Our Case Number: ABP-317660-23

Re: Busconnects Kimmage to city centre core bus corridor scheme
Kimmage, Dublin

KIMMAGE TO CITY CENTRE CORE BUS CORRIDOR SCHEMELANDSCAPING AND URBAN REALM

BCIDD-ROT-ENV_LA-0011_ML_00-DR-LL-0005 Sheet 4 of 14 (general note to entire route)

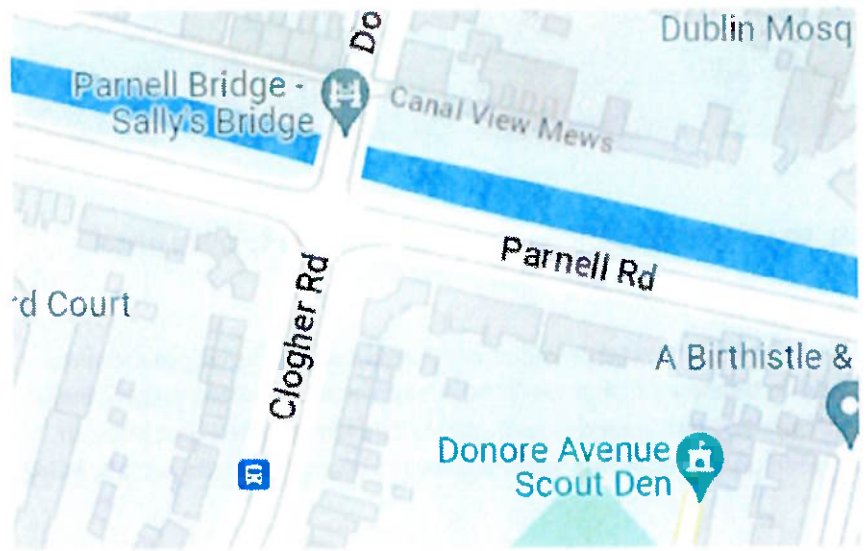
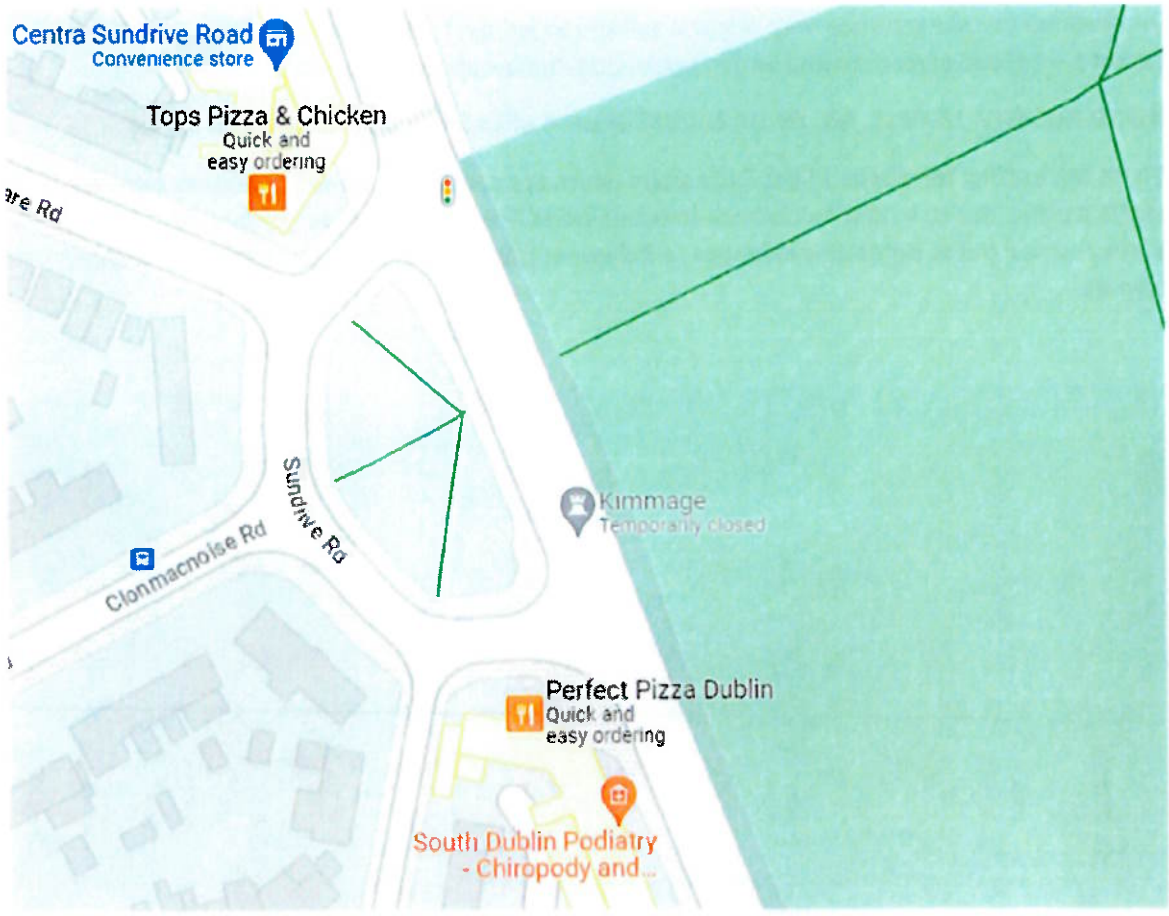
There are existing telephone / light / sign poles which are poorly located which prevent two way traffic due to minimum distance between poles & boundary wall to footpath. It is an particularly an issue when meeting with prams or wheelchairs The concrete foot paths have been shown as yellow indicating no amendment to locations. These poles should be repositioned while the improvement works are underway. Suggest survey carried out to determine locations to full layout (sheet 1 – 14) and correct amend within layouts. See below photo for example

There are existing telephone / light / sign poles which are poorly located which prevent two way walking traffic due to minimum distance between poles & boundary wall to the footpath. The concrete foot paths have been shown as yellow indicating no amendment to locations. This poles should be repositioned while the works are underway. These poles should be repositioned while the

improvement works are underway. Suggest survey carried out to determine locations to full layout (sheet 1 – 14) and correct amend within layouts. See below photo for example.

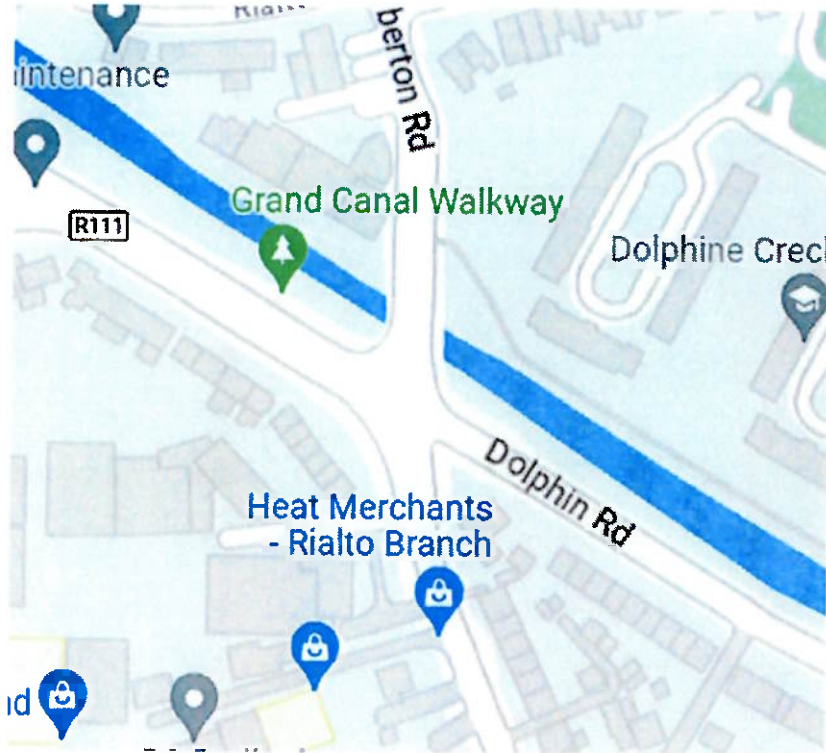
There are existing telephone / light / sign poles which are poorly located which prevent two way walking traffic due to minimum distance between poles & boundary wall to the footpath. Suggest survey carried out to determine locations to full layout (sheet 1 – 14) and correct amend within layouts.

BCIDD-ROT-ENV_LA-0011_ML_00-DR-LL-0003 Sheet 3 of 4

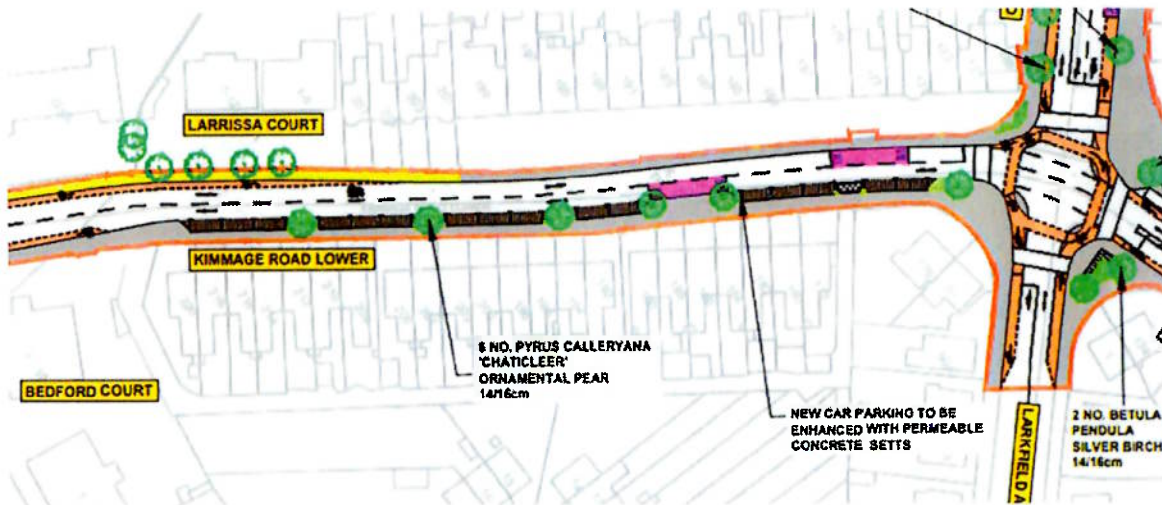
There are less tree provisions being provided to Lower Kimmage Road / Sundrive Rd road junction than was shown in the preferred route PDF issued previously. Suggest increasing.
